ACCESSION NBR: 8208030468 DOC. DATE: 82/07/27 NOTARIZED: NO DOCKET #
 FACIL: 50-389 St. Lucie Plant, Unit 2, Florida Power & Light Co. 05000389
 AUTH. NAME AUTHOR AFFILIATION
 UHRIG, R.E. Florida Power & Light Co.
 RECIPIENT NAME RECIPIENT AFFILIATION
 EISENHUT, D.G. Division of Licensing

SUBJECT: Forwards response to base plate flexibility action items noted in summary of 820525 meeting in Bethesda, MD.

Re: St. Lucie Unit No. 2
Docket No. 50-389
Response to Base Plate Flexibility Action Items

FLORIDA POWER & LIGHT COMPANY
ST. LUCIE UNIT 2
RESPONSE TO BASE PLATE FLEXIBILITY
ACTION ITEMS FROM MAY 25, 1982
MEETING WITH THE NRC

SUPPORT S7 (CONT.)

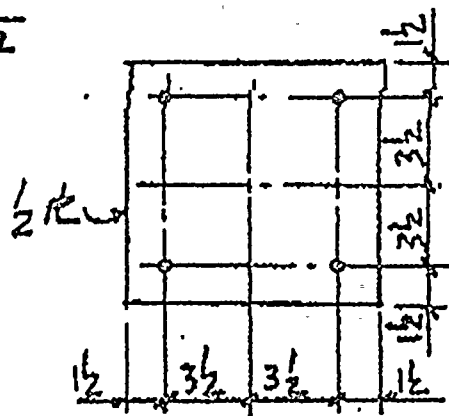
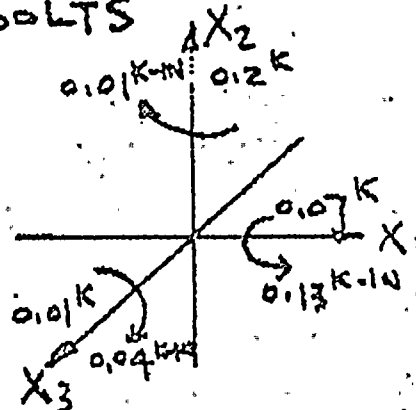
FP&L will do a calculation for the anchorage design using a "non-proportional" σ_y and submit the results to NRC formally by June 11, 1982.

The previously submitted hand calculation sample has been revised to reflect the use of a single value σ_y , as requested by NRC. A copy is enclosed (attachment A).

SUBJECT BASE PLATE ANALYSIS - CW-3006-6 (Release # 341)

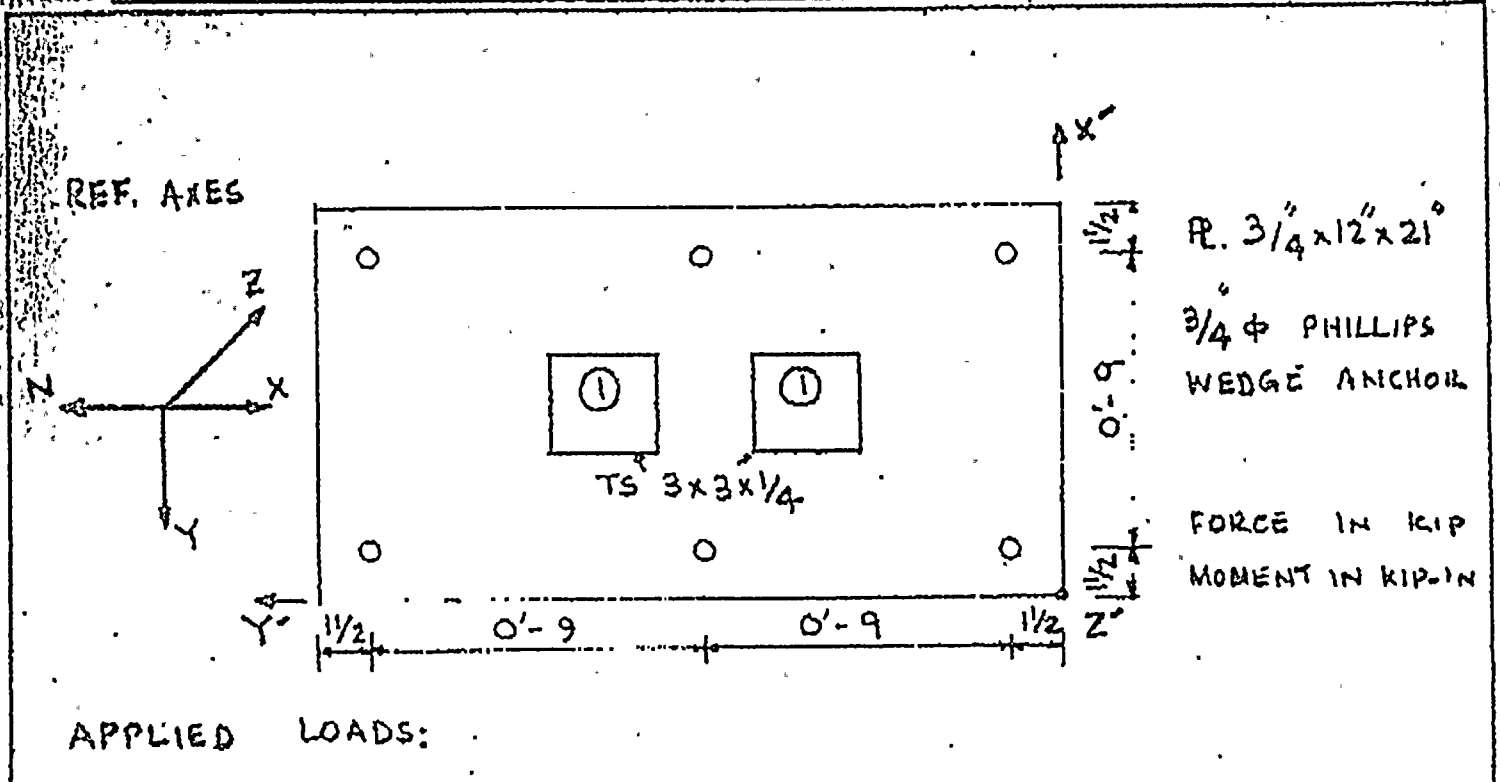
FP&L will determine if it is necessary to develop a sample calculation for base plates with other than 4 bolts for either single axis or biaxial bending.

Seven cases of support designs utilizing an expansion anchor detail of other than 4 bolts have been identified. 4 of these designs, judged to be the most severe, were analyzed using the ANSYS finite element computer program. All but one resulted in a factor of safety of at least 15 for bolt tension and shear. The sole exception was a factor of safety 13.1 for bolt tension. Ultimate capacity values used are based on actual tests performed at site. Analysis summary sheets for the 4 cases are enclosed (attachments B,C,D&E).

MAX. BOLT LOAD (TENSION) (KIP)	MAX. BOLT SHEAR (KIP)	MAX. R. STRESS (KSI)	ALLOW. BOLT TENSION	ALLOW. BOLT SHEAR
0.47	0.22	1.91	0.77	0.99
